Re: NH SEC Docket No. 2015-04: Public Service Company of New Hampshire d/b/a Eversource Energy (“PSNH” or the “Applicant”) for a New 115 kV Transmission Line from Madbury Substation to Portsmouth Substation.

NH PUC Docket DE 16-441, DE 16-442: Revisions to PSNH’s Petitions for Licenses to Construct and Maintain Electric Lines, Neutral Wire and Fiber Optic Cable Over and Across Public Waters and Public Lands of New Hampshire

Revisions to the
NHPUC Public Water and Public Land Crossing
License Applications

SUMMARY
Revisions between Originally Submitted Petition
And Revised Engineering Design

DOUBLE CKT F107 & 380
BETWEEN STR. 28 & 29
OYSTER RIVER, DURHAM, NEW HAMPSHIRE

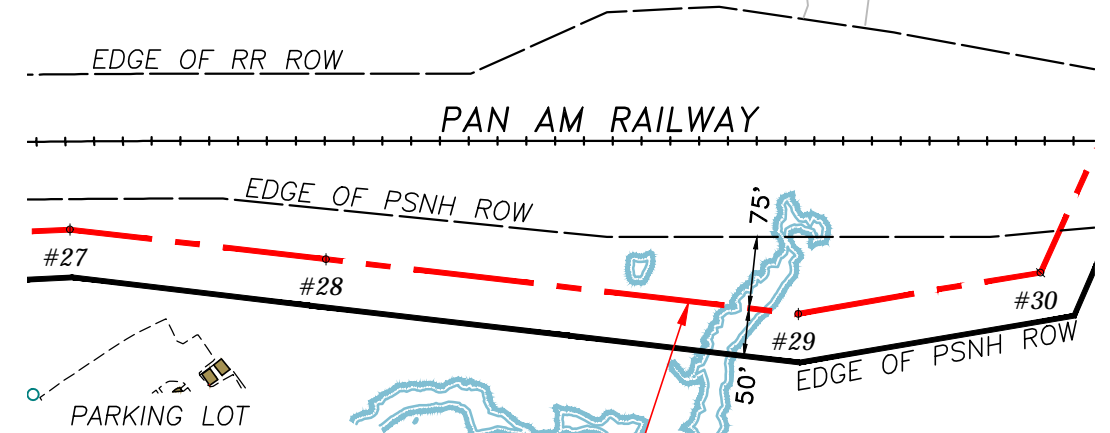
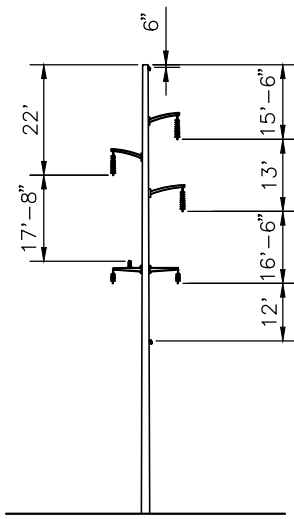
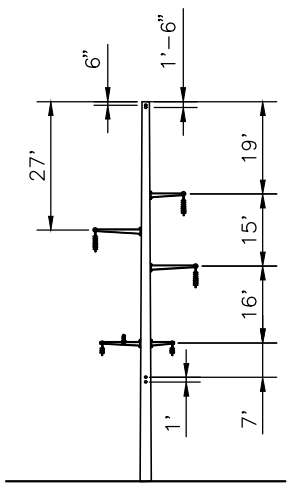
1. Paragraph #1- Revised Drawing number F10740901 (Exhibit 1) has been supplied. There are no changes to the location plan labeled as Drawing number F10740902 (Exhibit 2).

2. Paragraph #1- **Change** “PSNH” to “Eversource Energy”
3. Paragraph #3- **Change** “As shown on Exhibit 1...approximate separation at the structure of 7 - 15 feet vertically ... neutral wire is carried... approximately seven feet down below the 34.5kV phase wires.” to “As shown on Exhibit 1...approximate separation at the structure of 6 - 13 feet vertically...neutral wire is carried... approximately 12 feet down below the 34.5kV phase wires.”

4. Paragraph #5 Bullet 3- **Change** “...a clearance to the water surface of 57.1 feet. ... exceed the minimum clearance requirement of 30.1 feet by 27 feet under temporary emergency conditions during a 10-yr storm event.” to “...a clearance to the water surface of 58.4 feet. ... exceed the minimum clearance

- requirement of 30.1 feet by 28.3 feet under temporary emergency conditions during a 10-yr storm event.”
5. Paragraph #5 Bullet 4- **Change** “... the clearance would be 12 feet vertically ...” **to** “... the clearance would be 12.5 feet vertically ...”

6. Paragraph #5 Bullet 5- **Change** “...clearance would be 8.7 feet vertically and 1 foot horizontally from the shield wires to the closest phase wire...exceed the vertical requirement by 5.8 feet under worst case conditions.” **to** “...clearance would be 13.3 feet vertically and 1 foot horizontally from the shield wires to the closest phase wire...exceed the vertical requirement by 9.9 feet under worst case conditions.”

7. Paragraph #5 Bullet 6- **Change** “...clearance to the water surface of 36.7feet ... exceed the minimum clearance requirement of 28.5 feet by 8 feet under temporary emergency conditions during a 10-yr storm event.” **to** “...clearance to the water surface of 37.2 feet ... exceed the minimum clearance requirement of 28.5 feet by 8.7 feet under temporary emergency conditions during a 10-yr storm event.”

8. Paragraph #5 Bullet 7- **Change** “...clearance to the water surface of 30.3 feet. ...exceed the minimum clearance requirement of 25.5 feet by 4.8 feet under temporary emergency conditions during a 10-yr storm event.” **to** “...clearance to the water surface of 31.1 feet. ...exceed the minimum clearance requirement of 25.5 feet by 5.6 feet under temporary emergency conditions during a 10-yr storm event.”

9. Paragraph #5 Bullet 8- **Change** “...clearance of the closest 34.5kV line would be 1.5 feet vertically and 0 feet horizontally ... exceed the vertical requirement by 0.2 feet under worst case conditions.” **to** “...clearance of the closest 34.5kV line would be 2.5 feet vertically and 0 feet horizontally ... exceed the vertical requirement by 1.2 feet under worst case conditions.”

EVERSOURCE ENERGY		TRANSMISSION BUSINESS		5
DRAWN SCF		SINGLE CKT F107 BETWEEN STR. 119 & 120 PICKERING BROOK, NEWINGTON, NEW HAMPSHIRE		
ENGINEER KMS				
CHECKED APJ				
APPROVED -	SCALE AS NOTED	DATE 3/17/15	SHEET 1 OF 1	DRAWING NO. F10740903

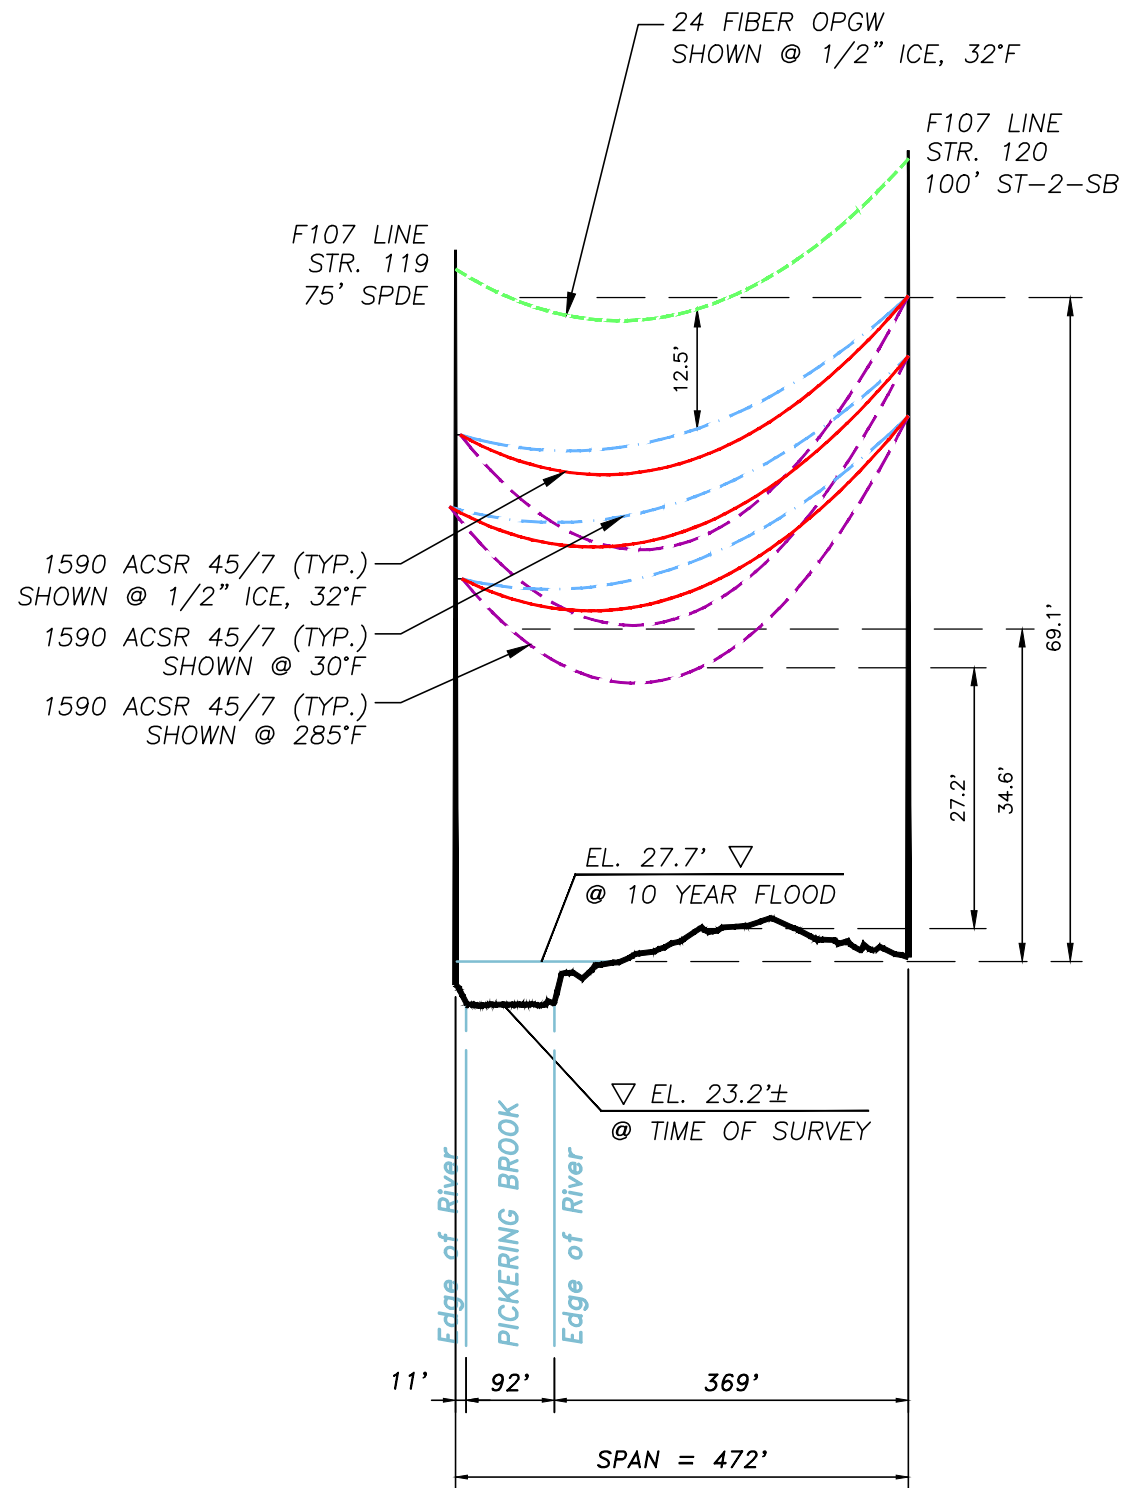
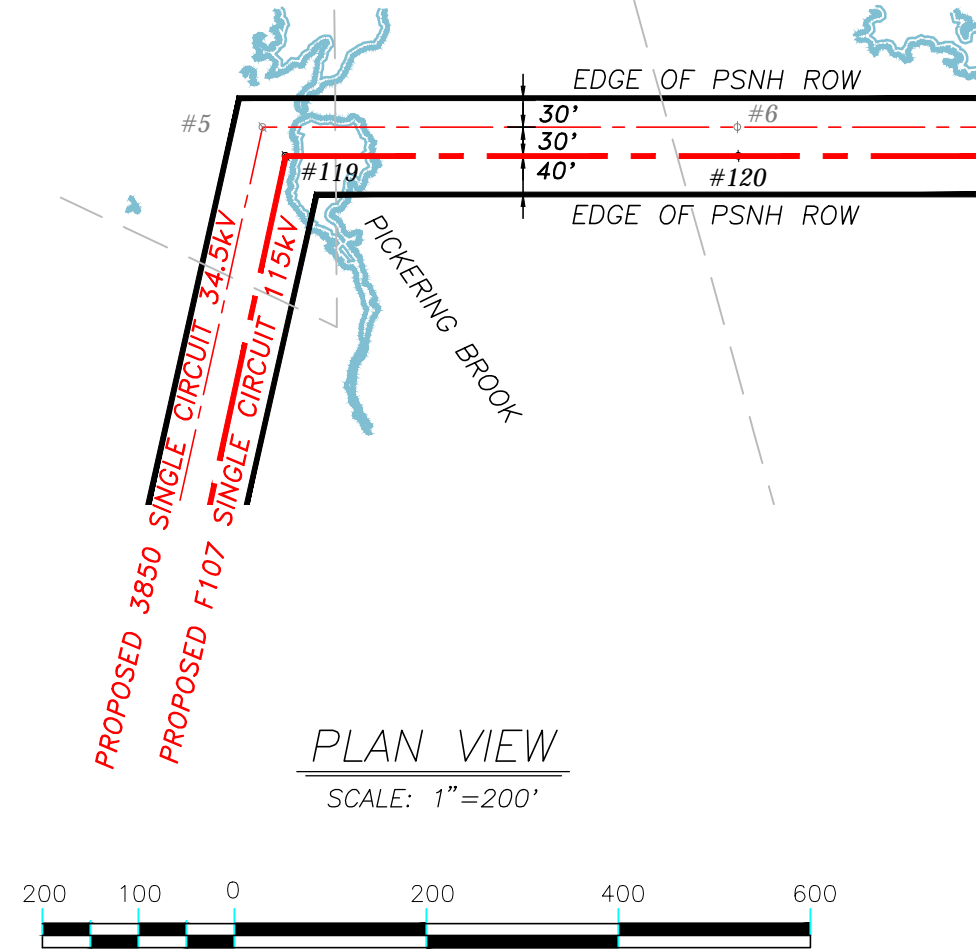
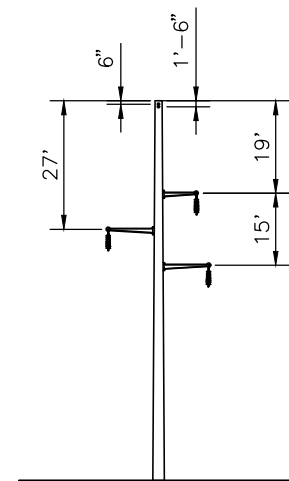
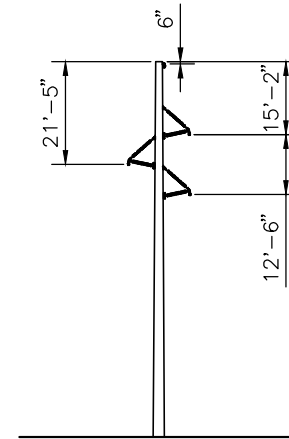
1. Paragraph #1- Revised Drawing numbers F10740903 (Exhibit 3) and 385040901 (Exhibit 5) have been supplied. There are no changes to the location plans labeled as Drawing numbers F10740904 (Exhibit 4) and 385040902 (Exhibit 6).

2. Paragraph #1- **Change** “PSNH” **to** “Eversource Energy”
3. Paragraph #3- **Change** “As shown on Exhibit 3...separation at the structure of 8 -15 feet vertically” **to** “As shown on Exhibit 3...separation at the structure of 6 -12.5 feet vertically”

4. Paragraph #3- **Change** “A clearance of 26.2 feet...NESC required clearance of 20.1 feet by 6.1 feet.” **to** “A clearance of 27.2 feet...NESC required clearance of 20.1 feet by 7.1feet.”

EVERSOURCE ENERGY		TRANSMISSION BUSINESS		5
DRAWN SCF		SINGLE CKT 3850		
ENGINEER KMS		BETWEEN STR. 5 & 6		
CHECKED APJ		PICKERING BROOK, NEWINGTON, NEW HAMPSHIRE		
APPROVED -	SCALE AS NOTED	DATE 8/4/15	SHEET 1 OF 1	DRAWING NO. 385040901

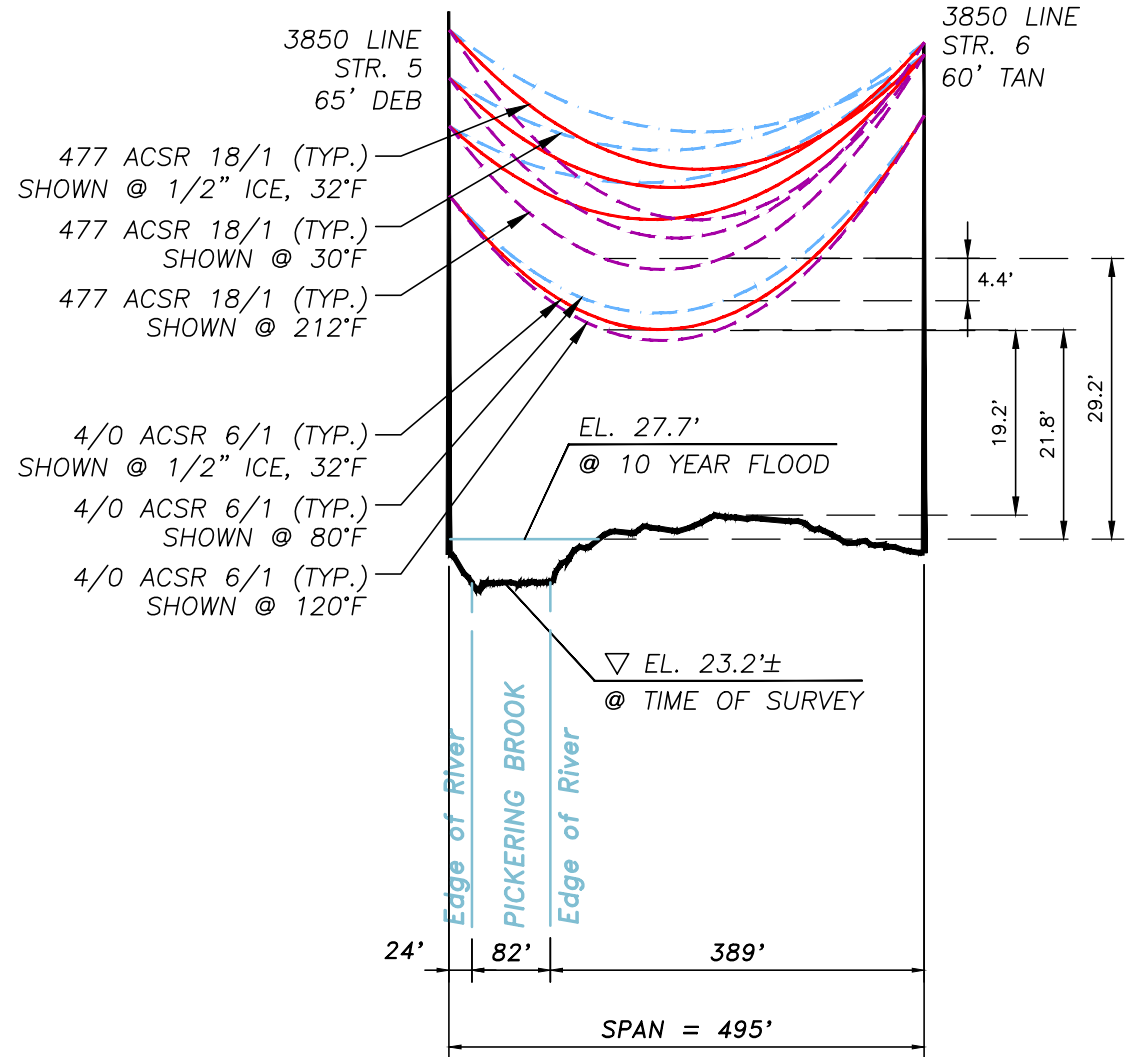
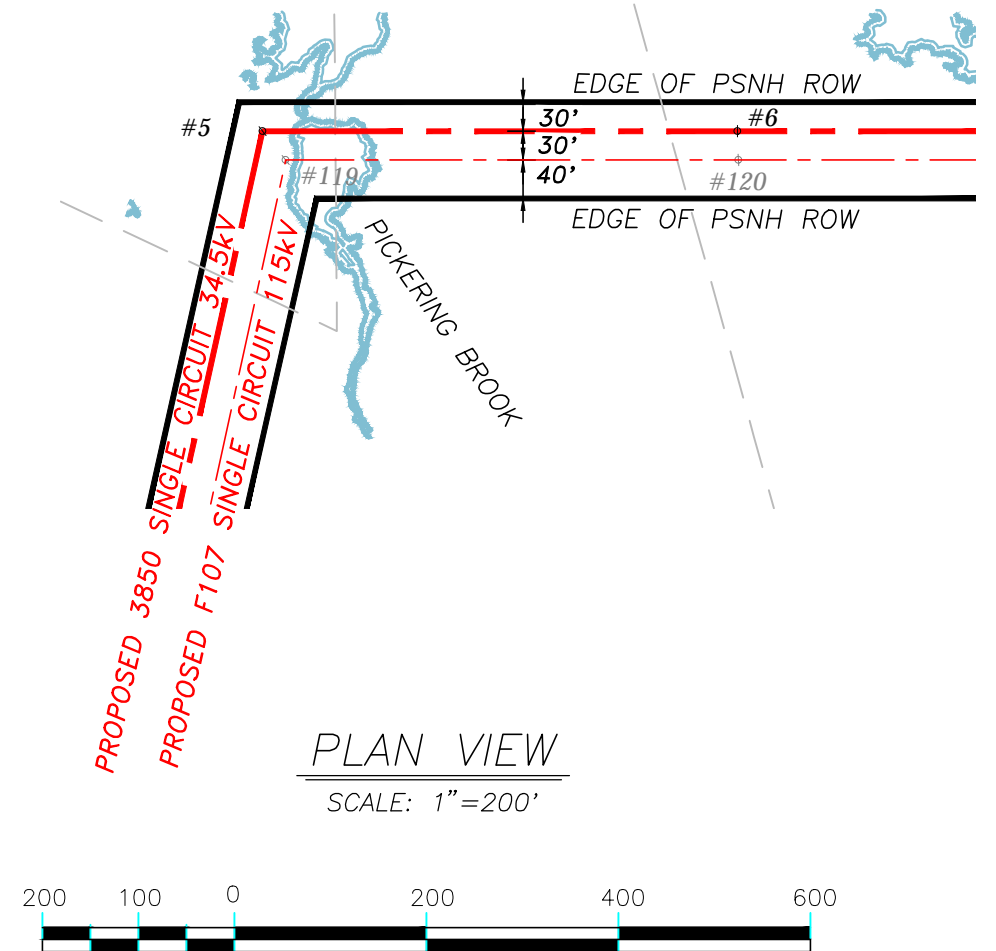
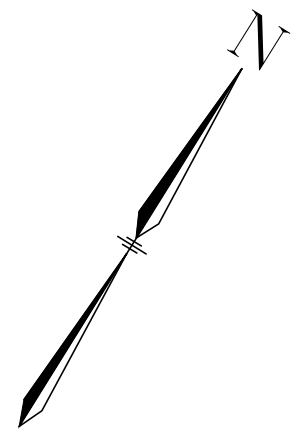
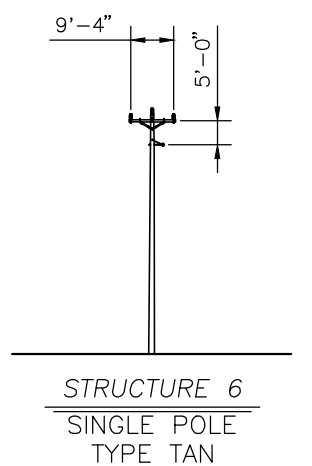
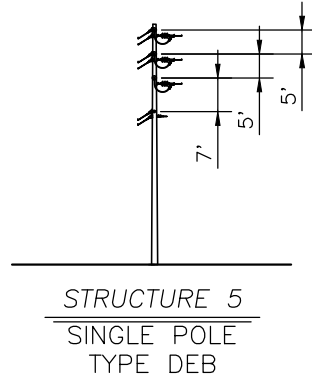
5. Paragraph #4- **Change** “...1-pole, direct embed, 60 foot pole (eight feet embedded), wood deadend structure (western side)...” **to** “...1-pole, direct embed, 65 foot pole (8.5 feet embedded), wood deadend structure (western side)...”

6. Paragraph #4- **Change** "...separation at the structure of five feet vertically and 0-9 feet horizontally in a horizontal configuration." to "...separation at the structure of five feet vertically and 0 feet horizontally in a vertical configuration."

7. Paragraph #4- **Change** "for Structure 5...approximately five feet..." to "for Structure 5...approximately seven feet..."
8. Paragraph #4- **Change** "A clearance of 21 feet between...NESC required clearance of 15.5 feet by 5.5 feet." to "A clearance of 19.2 feet between...NESC required clearance of 15.5 feet by 3.7 feet."

9. Paragraph #6, Bullet 3- **Change** "...a clearance to the water surface of 34.1 feet.... exceed the minimum clearance requirement of 22.1 feet by 12 feet under temporary emergency conditions during a 10-yr storm event." to "...a clearance to the water surface of 34.6 feet.... exceed the minimum clearance requirement of 22.1 feet by 12.5 feet under temporary emergency conditions during a 10-yr storm event."

10. Paragraph #6, Bullet 4- **Change** "Under these conditions the clearance would be 13.5 feet vertically..." to "Under these conditions the clearance would be 12.5 feet vertically..."

11. Paragraph #6, Bullet 5- **Change** "...a clearance to the water surface of 31.9 feet. ...exceed the minimum clearance requirement of 20.5 feet by 11.4 feet under temporary emergency conditions..." to "...a clearance to the water surface of 29.2 feet. ...exceed the minimum clearance requirement of 20.5 feet by 8.7feet under temporary emergency conditions..."

12. Paragraph #6, Bullet 6- **Change** "...a clearance to the water surface of 23.5 feet. ... exceed the minimum clearance requirement of 17.5 feet by 6 feet under temporary emergency conditions during a 10-yr storm event." to "...a clearance to the water surface of 21.8 feet. exceed the minimum clearance requirement of 17.5 feet by 4.3 feet under temporary emergency conditions during a 10-yr storm event."

13. Paragraph #6, Bullet 7- **Change** "...clearance of the closest 34.5kV line would be 2.4 feet vertically and 0 feet horizontally from the neutral wire ... will exceed the vertical requirement by 1.1 feet under worst case conditions." to "...clearance of the closest 34.5kV line would be 4.4 feet vertically and 0 feet horizontally from the neutral wire ... will exceed the vertical requirement by 3.1 feet under worst case conditions."
